NL Nuclear

July 6, 1979

Subject: NLI 10/24 Rail Cask
Certificate of Compliance No. 9023, Rev. 0

Attachment No. 1
Revision List - NLI 10/24 Rail Cask
Safety Analysis Report

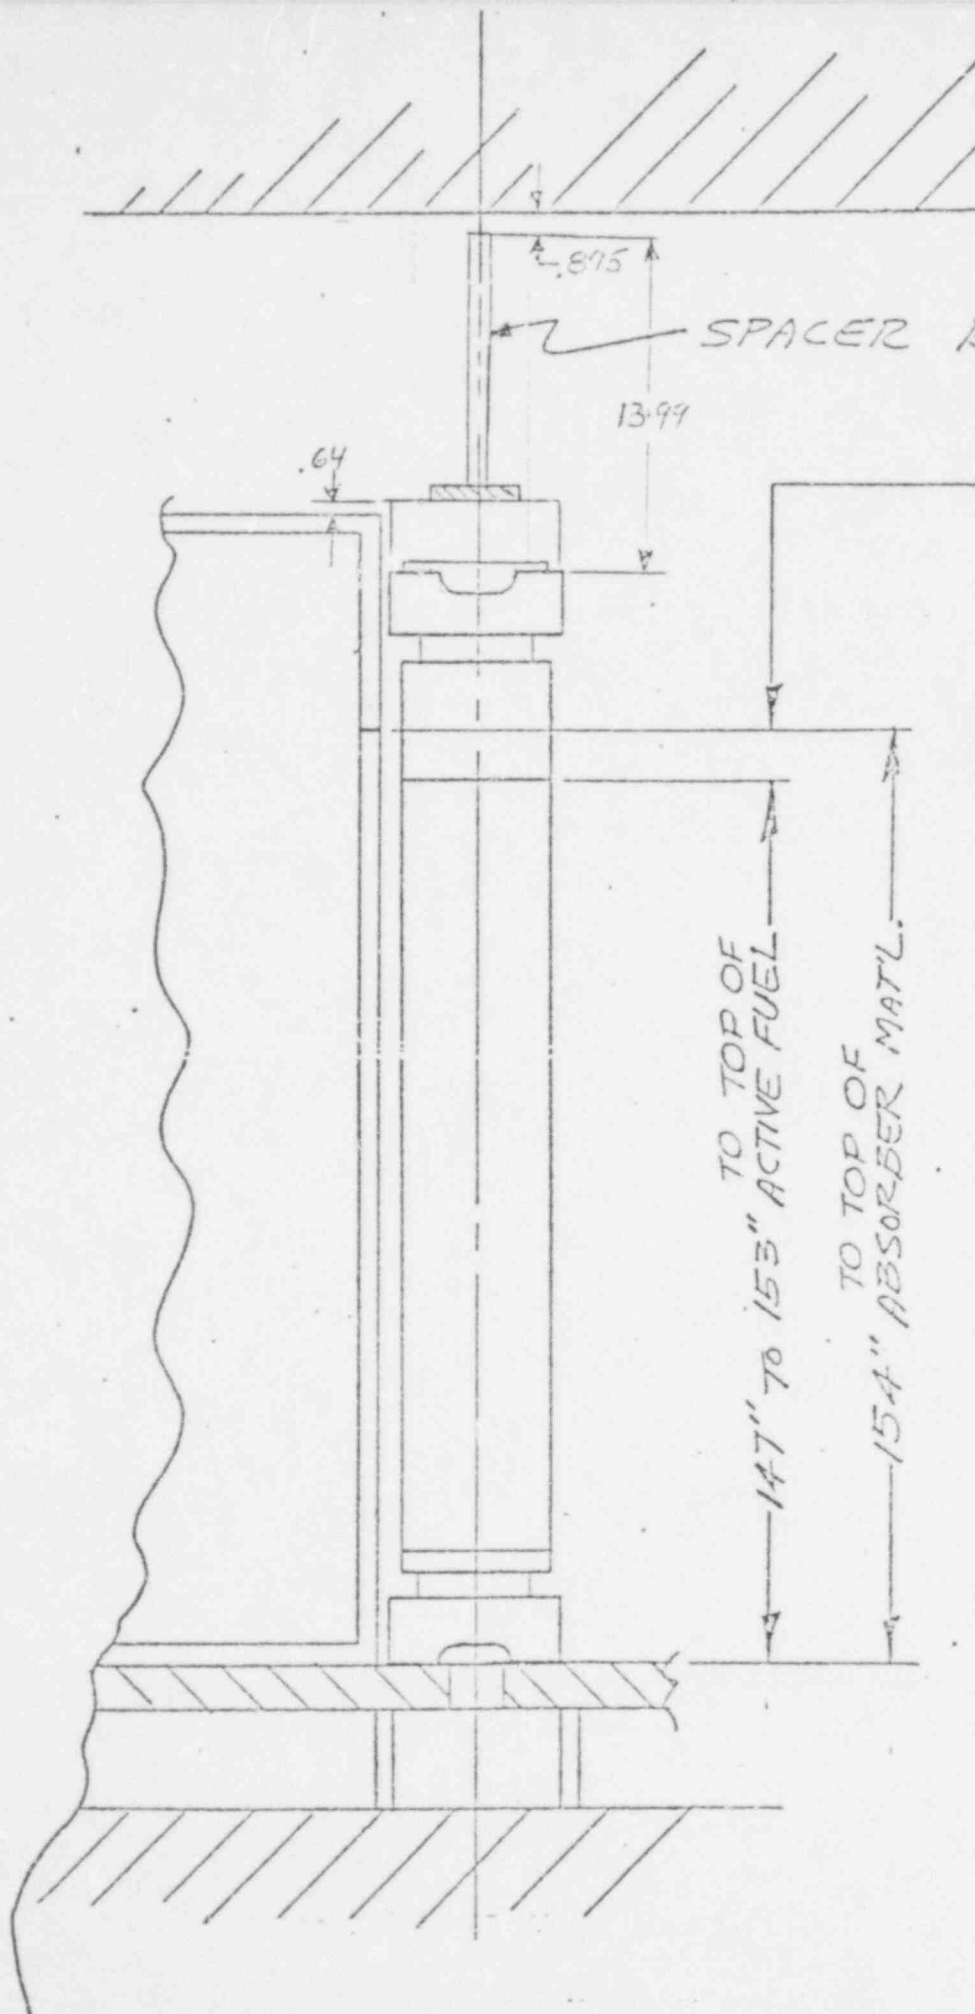
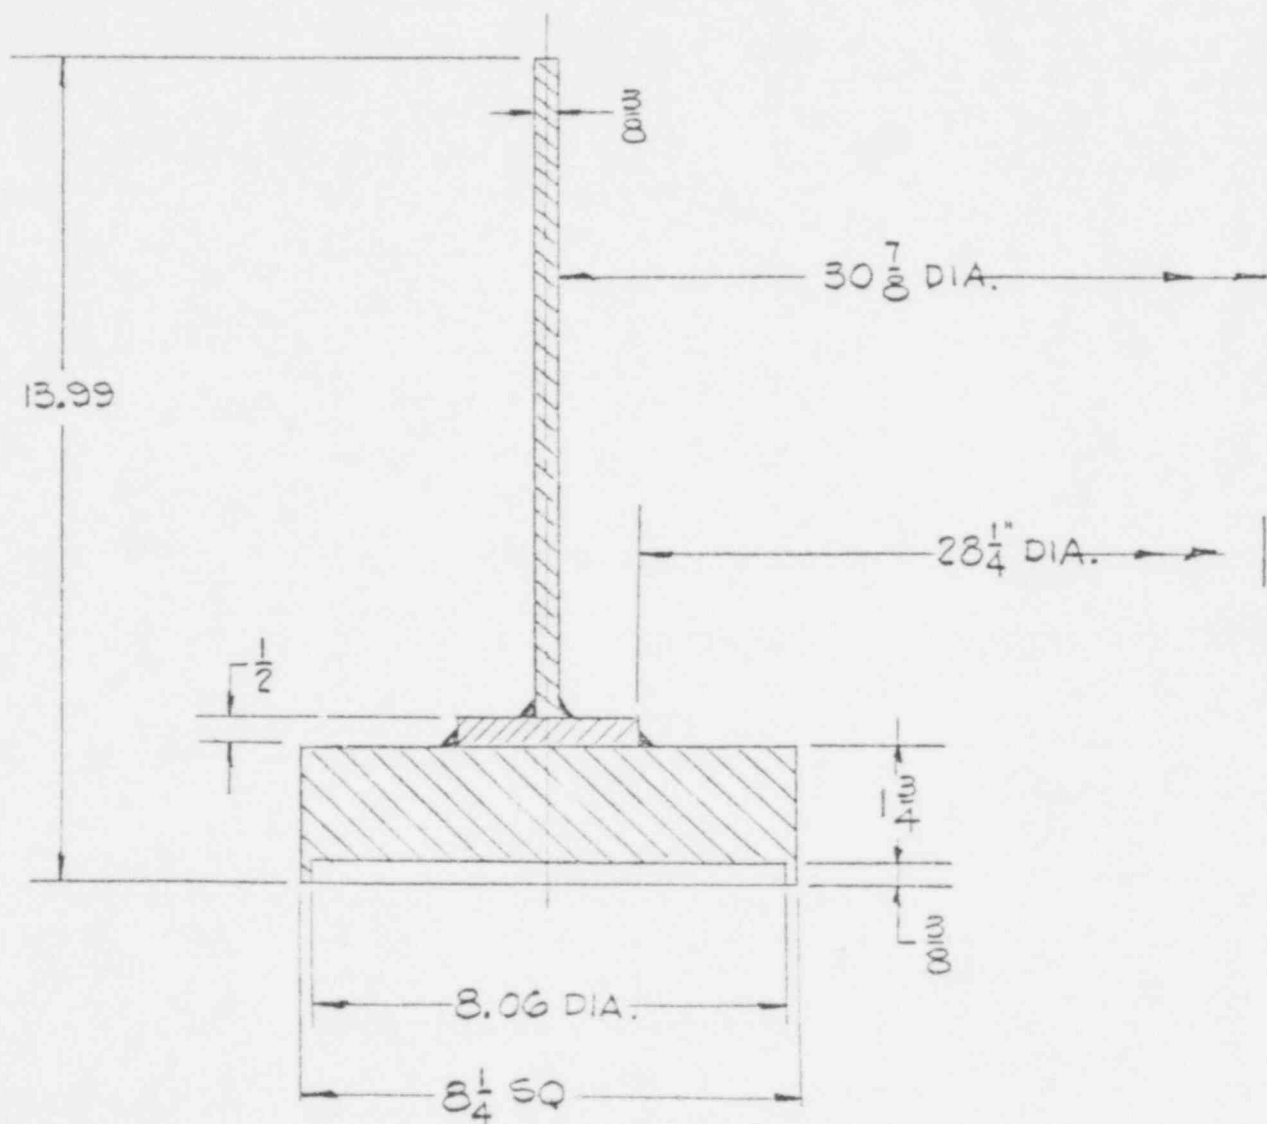
- 1) Sketch on page XI-4-73 has been revised to correctly show the 28 1/4 inch dimension.
- 2) The procedure that will be used to assure that the PWR spacer length will result in the desired gap is as follows. Depending on whether the particular fuel assembly length is longer or shorter than the reference fuel length (159.8) add or subtract the difference to both the 13.99 and 2.13 dimensions shown on Drawing 70655F to obtain the adjusted fuel spacer heights. Drawing 70655F has been revised to explain the procedure for obtaining adjusted spacer plug dimensions.

- 3) The dimension is locating the top edge of the absorber material relative to the fuel support plate in the basket. The absorber material is 151 inches long and is located 3 inches above the support plate as shown on drawing 70652F. The combination of the two dimensions locates the top edge of the absorber material 154 inches from the support plate in the basket. The words "TO TOP OF" have been added to clarify the dimension.
- 4) The referenced figure on page XI-4-68 should be 3.6.1.2.1(c). The percent of ultimate stress at temperature should be 72%. The exposure time used to obtain 72% at 390°F is 1000 hours. The 1000 hours is more than adequate to cover elapsed transport time. The loading being analyzed is not a constant load but a momentary load resulting from the hypothetical drop accident criteria.
